application

PROPERTY: 1417 NW 20TH AVE. PORTLAND, OREGON
RE: APPLICATION FOR DESIGN ADVICE REQUEST
SUBMITTED: AUGUST 20, 2015

DAR 01 comments | challenges

building heights

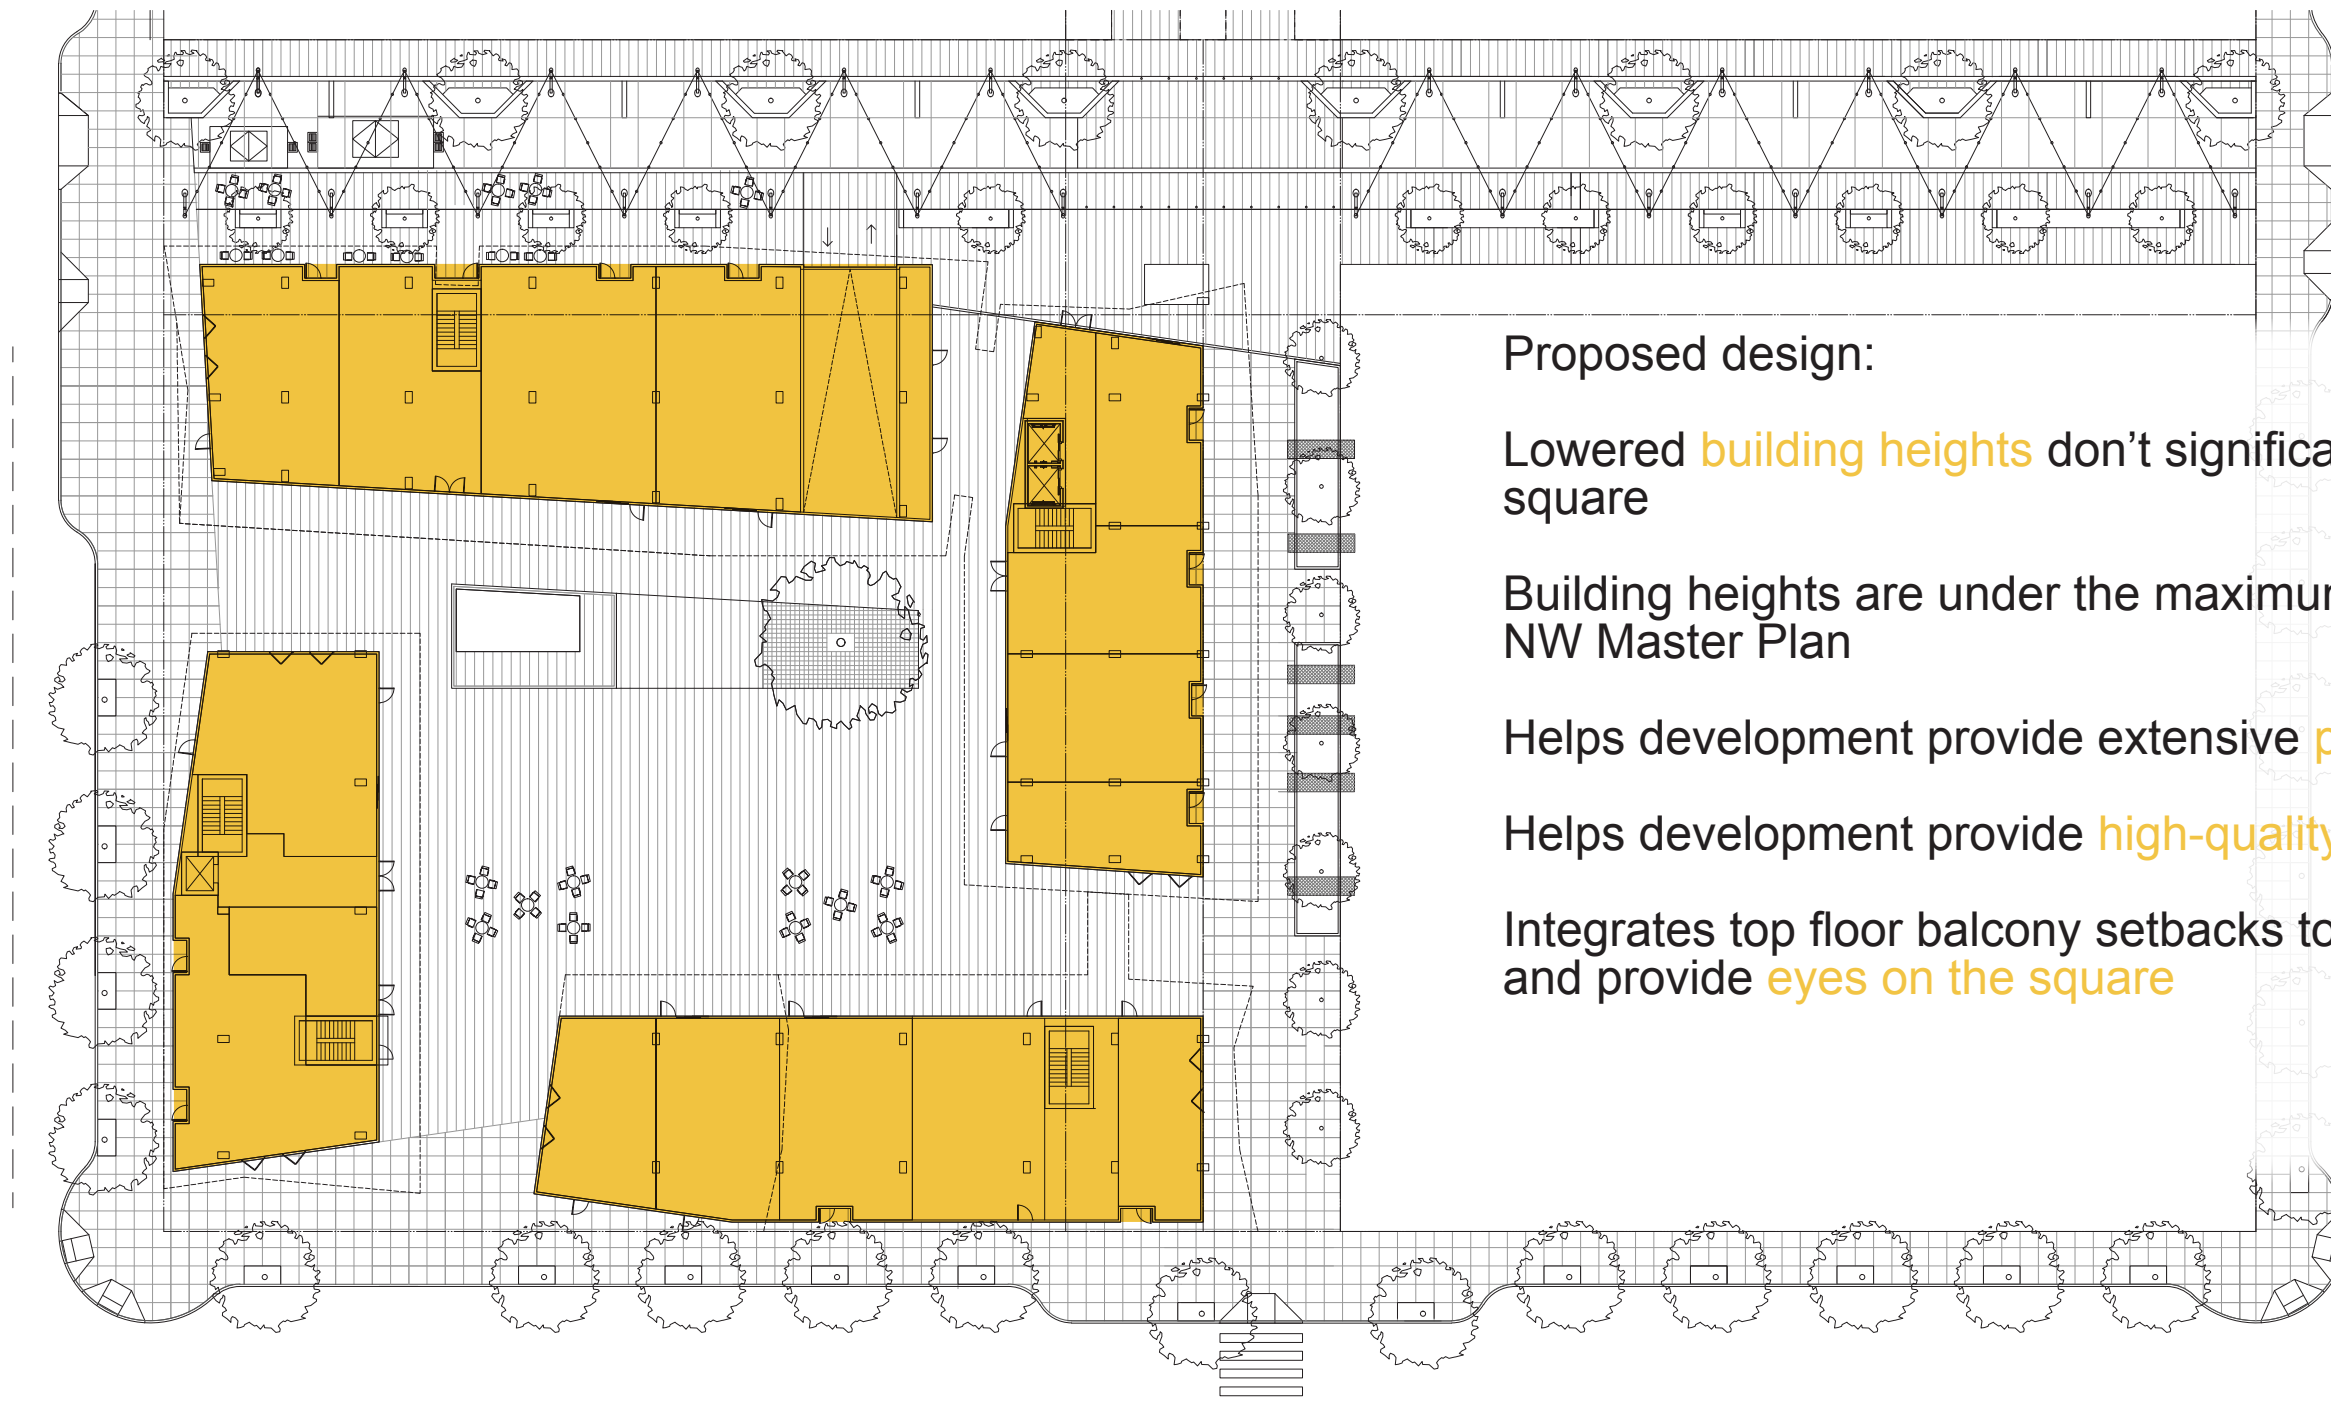
3. Provide adequate building height to support the project while ensuring solar access, both of which are critical to the vibrancy and success of the Square.

Proposed design:

Lowered **building heights** don't significantly alter **solar access** to the square

Building heights are under the maximum **allowable heights** per the NW Master Plan

Helps development provide extensive **public amenities**

Helps development provide **high-quality materials**

Integrates top floor balcony setbacks to **reduce the building scale** and provide **eyes on the square**

nw quimby street

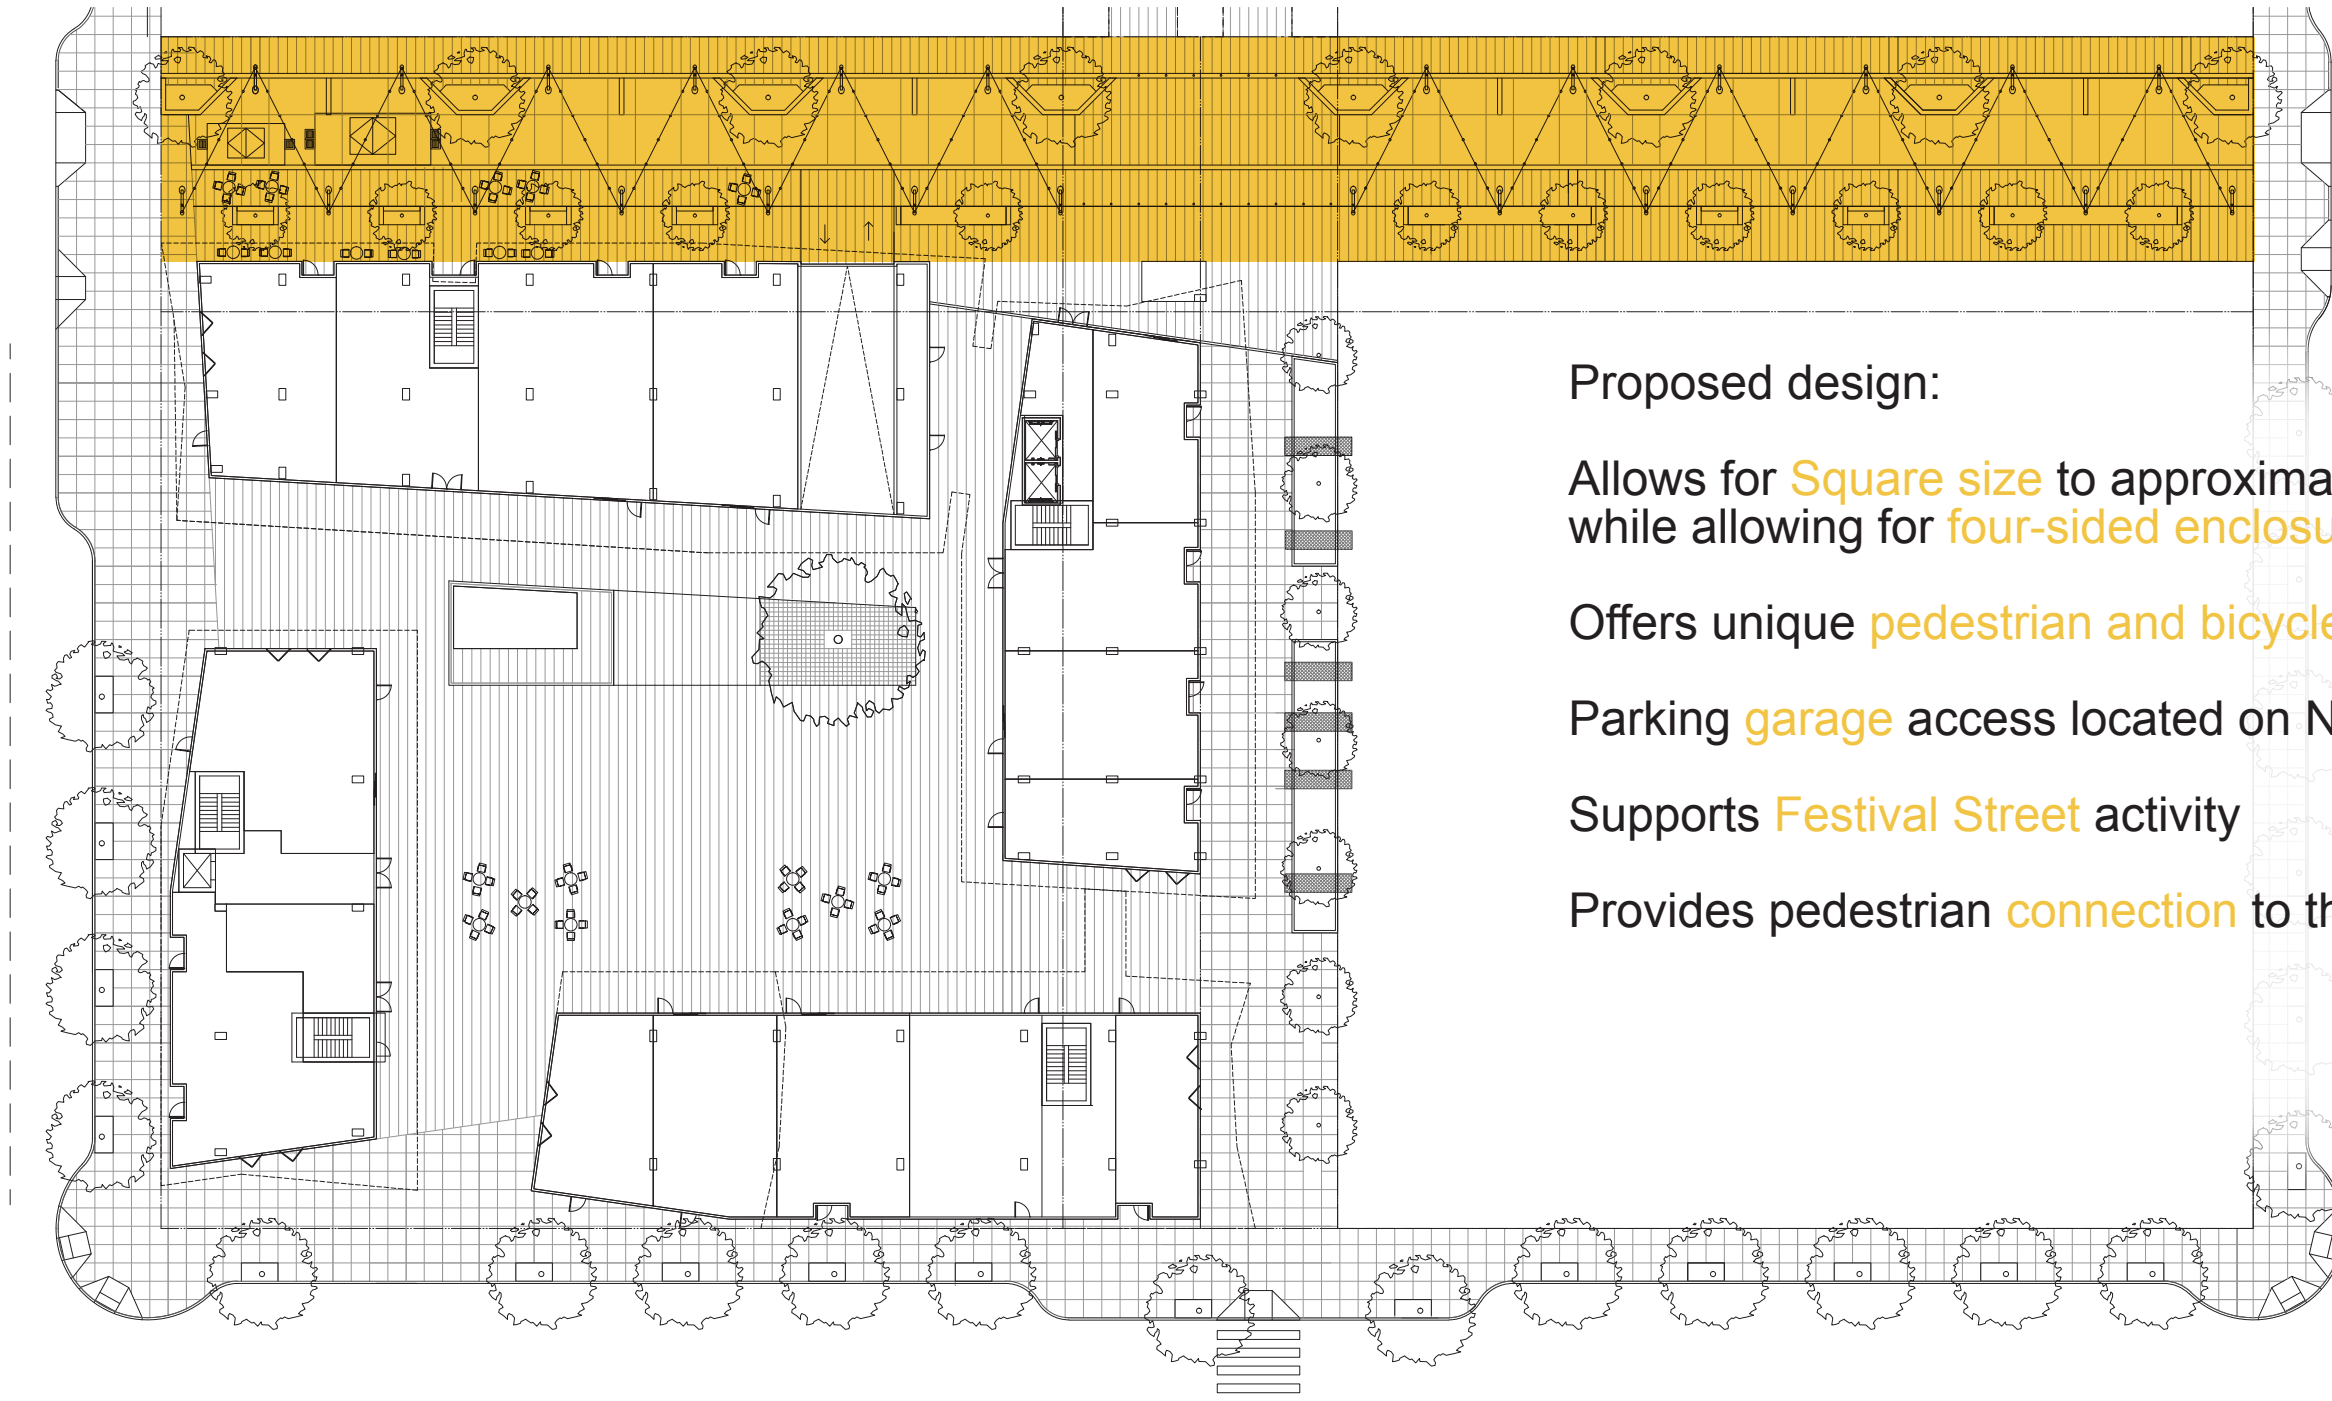
4. Address the function of NW Quimby St. to support pedestrian and bicycle circulation and integrate vehicular uses.

Proposed design:

Allows for **Square size** to approximate Master Plan requirements while allowing for **four-sided enclosure**

Offers unique **pedestrian and bicycle** realm

Parking **garage** access located on NW Quimby

Supports **Festival Street** activity

Provides pedestrian **connection** to the **park** and the **square**
